TO : HOLDERS OF SERVICE BULLETIN SB 25-1111432 FOR THE
RESTRAINT SYSTEMS WITH PNR 1111430-XX AND 1111475-XX

TRANSMITTAL SHEET

REVISION 003
dated Sep 24/25

Information Regarding the Potential Failure of the Guarded Rotary Buckles with Plastic Handles PNR 1111430-XX and PNR 1111475-XX

Figure 5
Optional Inspection Tool PNR 111432-GA

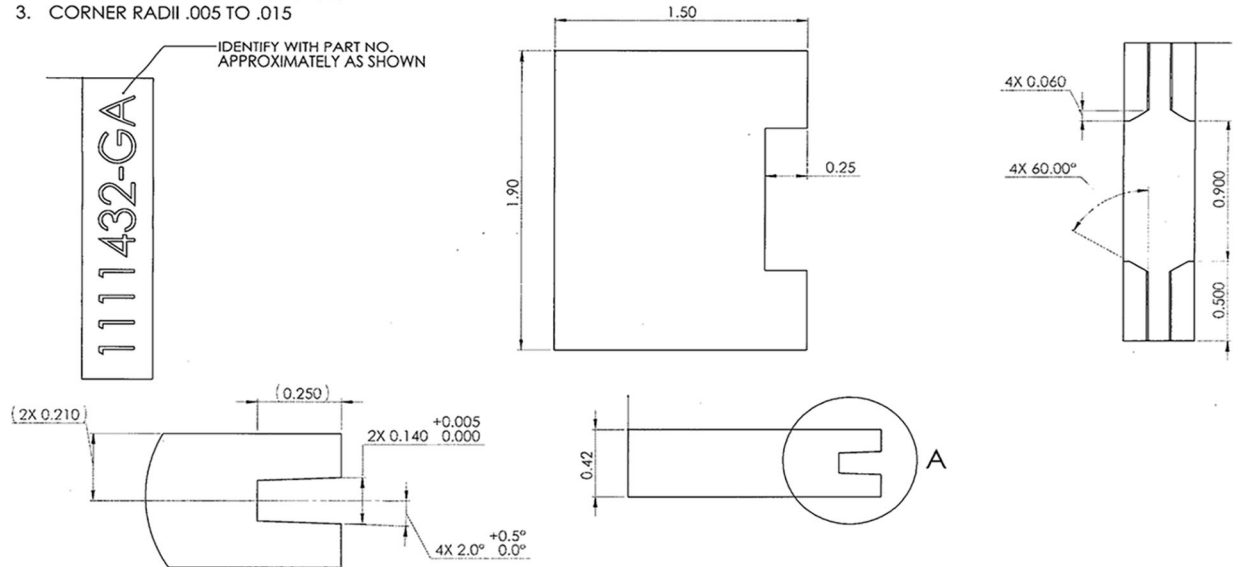
- (1) Measure the handles in accordance with Figure 3 on page 20 and Figure 4 on page 20 to make sure the handles are less than 0.125 inches at the top edge. Parker Meggitt has created an optional inspection tool (PNR 1111432-GA). Contact Parker Meggitt for purchase of the inspection tool. Refer to Figure 5 on page 21 for correct use of the optional inspection tool.

NOTE 2 : If using an inspection tool, make sure the tool fits over the vanes and the center is flushed to the button.

NOTE 1 : Acceptable parts will have a vane dimension LESS than or equal to 0.125 inch at the top edge.

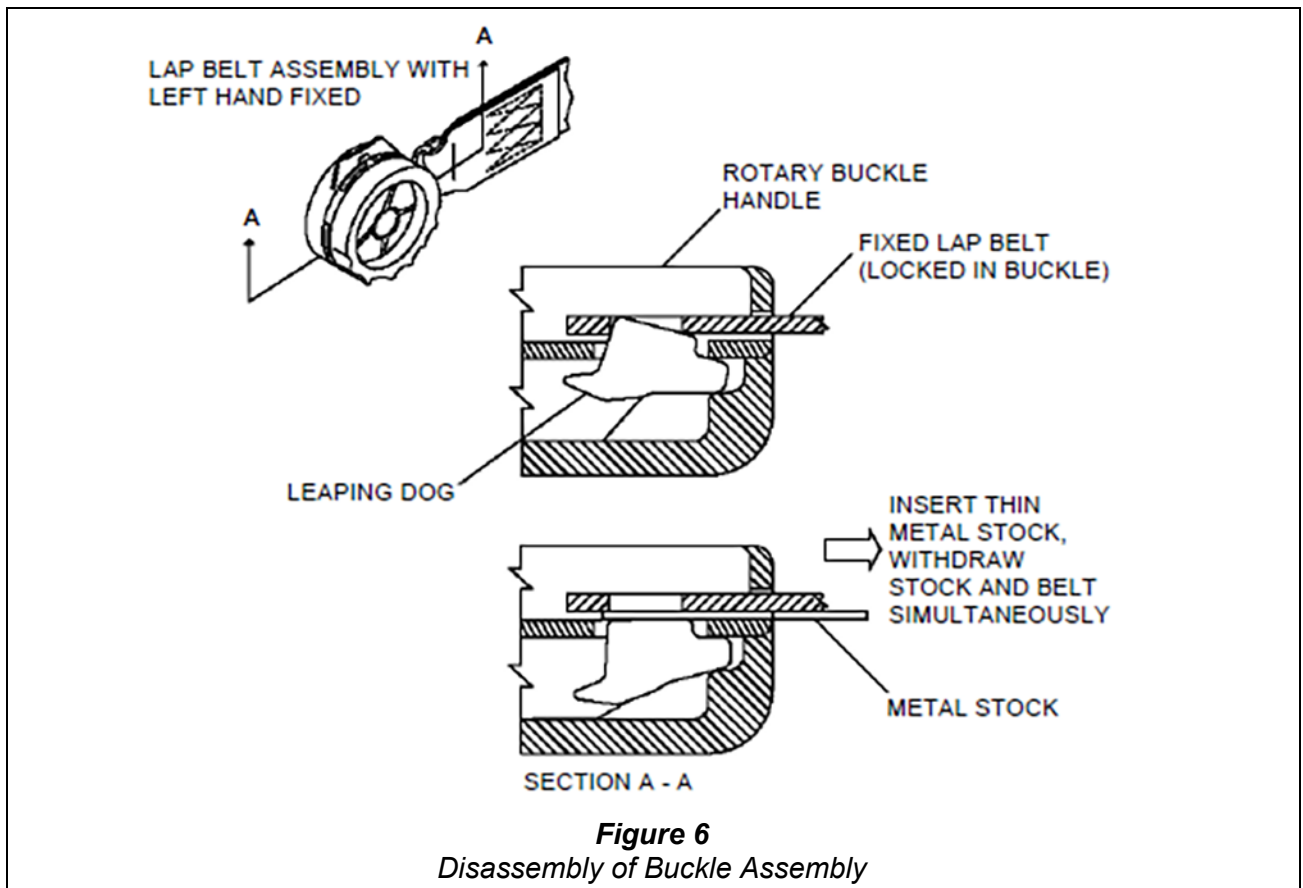
- (1) Insert a piece of thin metal stock into the slot of the rotary buckle and push inward between the fitting and the buckle locking mechanism (refer to Figure 6).
- (2) Pull the fitting from the buckle.
- (3) Remove the buckle pad as necessary.
